Project: Wayfinding Signage Program

RE: Addendum # 5
of Pages: (7)

The following information is provided in response to written questions received in connection with the Battery Park City Authority (“BPCA”) Request for Proposals (“RFP”) issued on January 18, 2017 for its “Wayfinding Signage Program” project (the “Project.”)

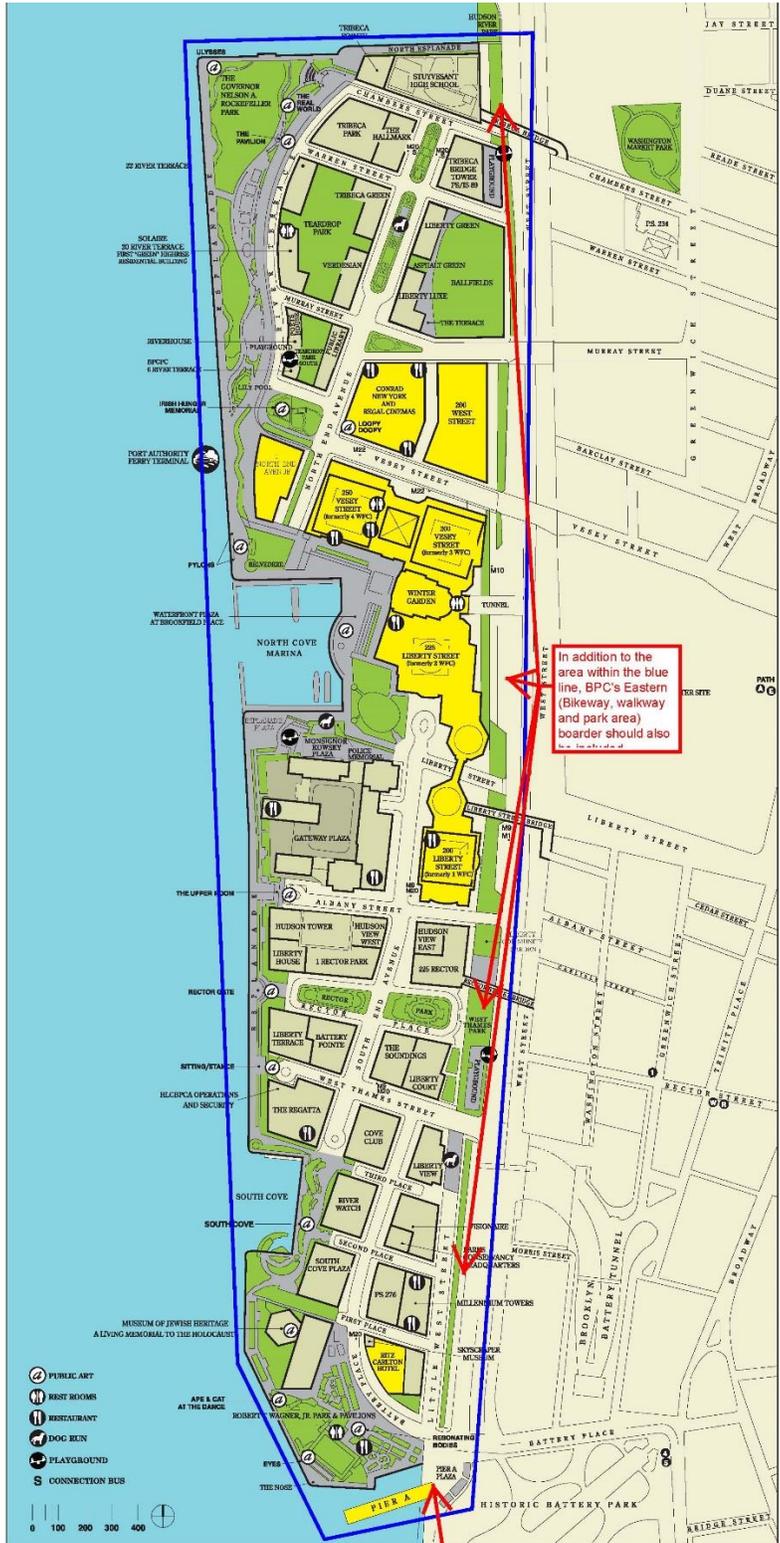
31. Please provide clarification with respect to the physical geographic boundaries (North, East, South, West street borders and/or a map or diagram showing the area) that should be considered within the scope of this project.

Response: *A diagram of the project area is attached on the following page.*

In addition to the area within the blue line, BP's Eastern (Bikeway, walkway and park area) border should also

Pier A and the Plaza is included
